QUEANBEYAN-PALERANG REGIONAL COUNCIL

ITEM 12.7 MAJARA STREET PLANNING PROPOSAL

ATTACHMENT 2 GATEWAY DETERMINATION FOR PLANNING PROPOSAL TO
 AMEND PALERANG LOCAL ENVIRONMENTAL PLAN
 2014 - MAJARA STREET BUNGENDORE
 (PP_2017_QPREG-001-00)

**Planning proposal to amend Palerang Local Environmental Plan 2014 –
Majara Street Bungendore (PP_2017_QPREG_001_00)**

Figure 4: Majara St, Bungendore, Lots 3-4 Proposed Subdivision Layout

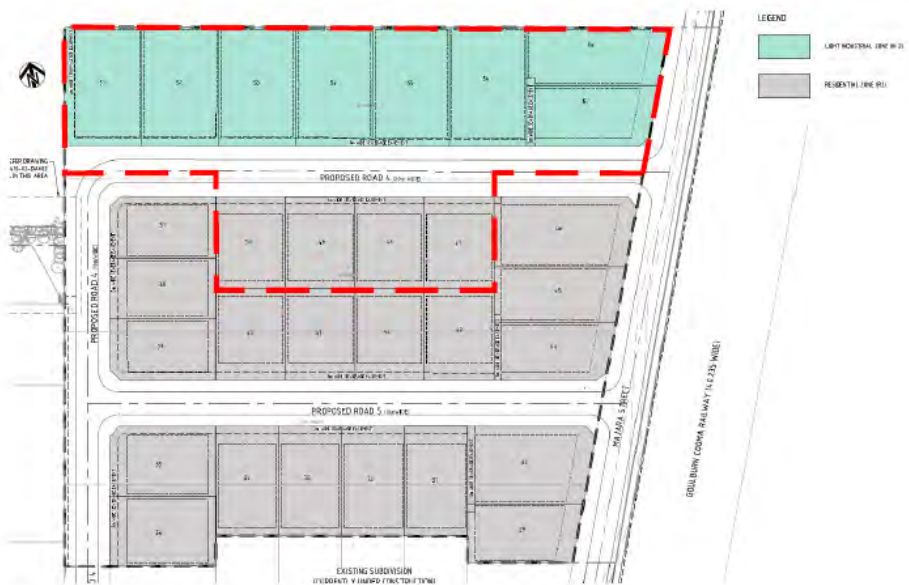
Road layout - Page 6 of the traffic study shows the proposed lot and road layout (shown below).

It is proposed that the road currently being constructed for the residential subdivision south of Lot 3 DP 1195030 will be used to access the lots to be created from Lot 3 DP 1195030 (shown in green). Additionally, the four lots included in the red area which are not part of the current subdivision will be included in the subdivision concerning Lot 3 DP 1195030. Whilst this approach is considered appropriate no final decision should be made until an acoustic report is received as a buffer area between the concrete batching plant and the proposed western residential lot may need to be included (see below re noise). Any measures required to mitigate noise issues will be constructed at the proponent's expense.

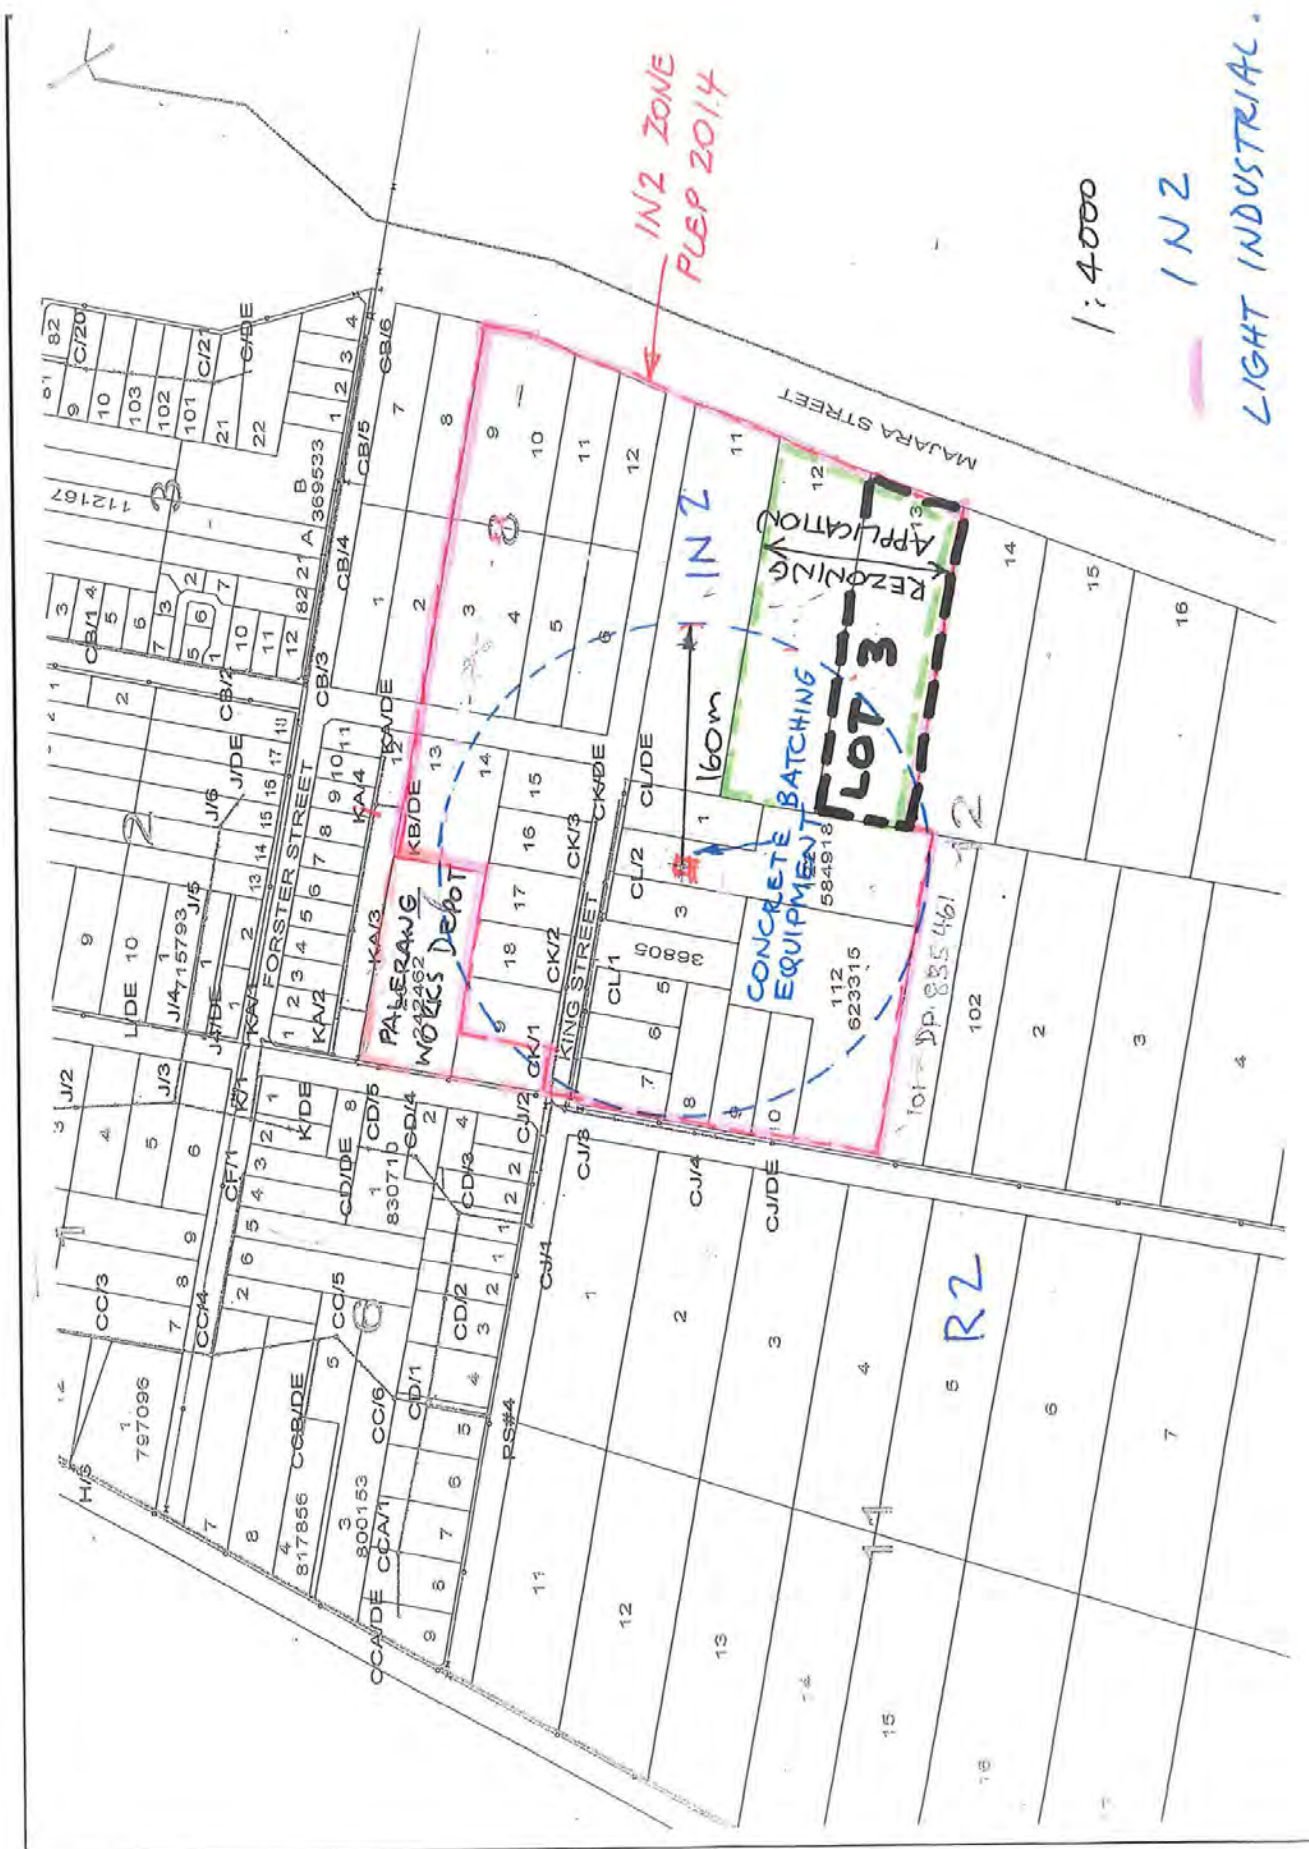
The attached plan shows the relationship between industrial and residential lands which would have been carefully considered by Council planners when these zones were created.

It is quite clear that the planners were aware of the need to exclude residential zoning from the proximity of the concrete batching plant.
